PRODUCT CHANGE NOTIFICATION

#PCN-DC-163S-14

Business Unit	Product Line Code	Type of Change	Action	Date of issue
DC	ABQ	Mechanical	Notify Distributors and Field	6/05/2014

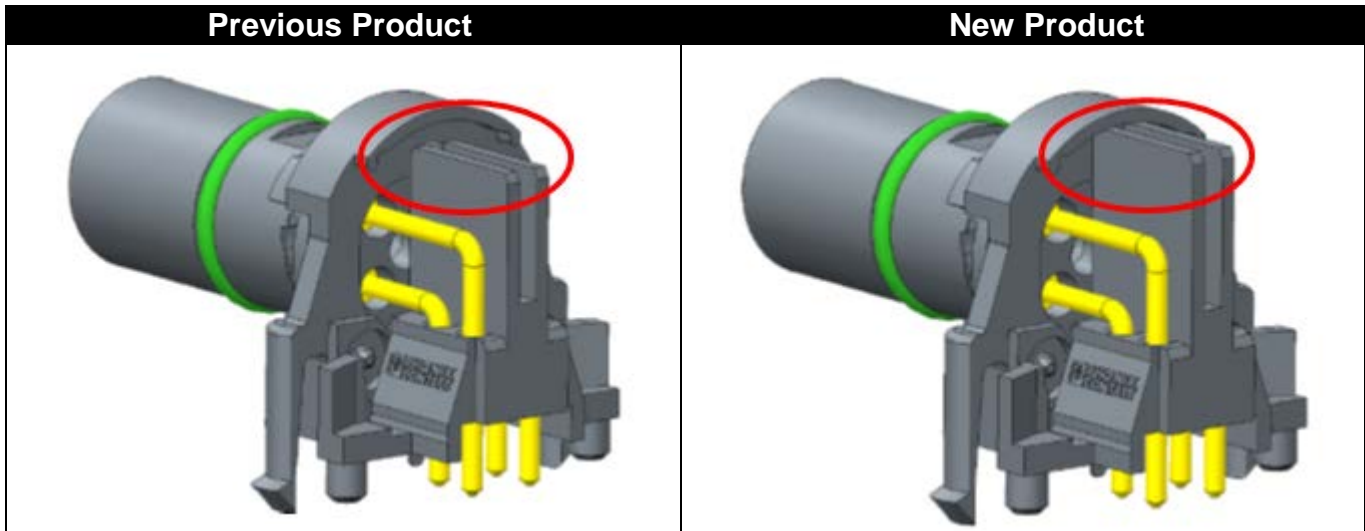
To increase the retention function of the contact clip, the length of the contact clip for the 4 and 5-pin male version will be increased. With the modification there is also an additional end stop to secure the position of the contact clip. All technical performance and the mounting recommendations will be unchanged.
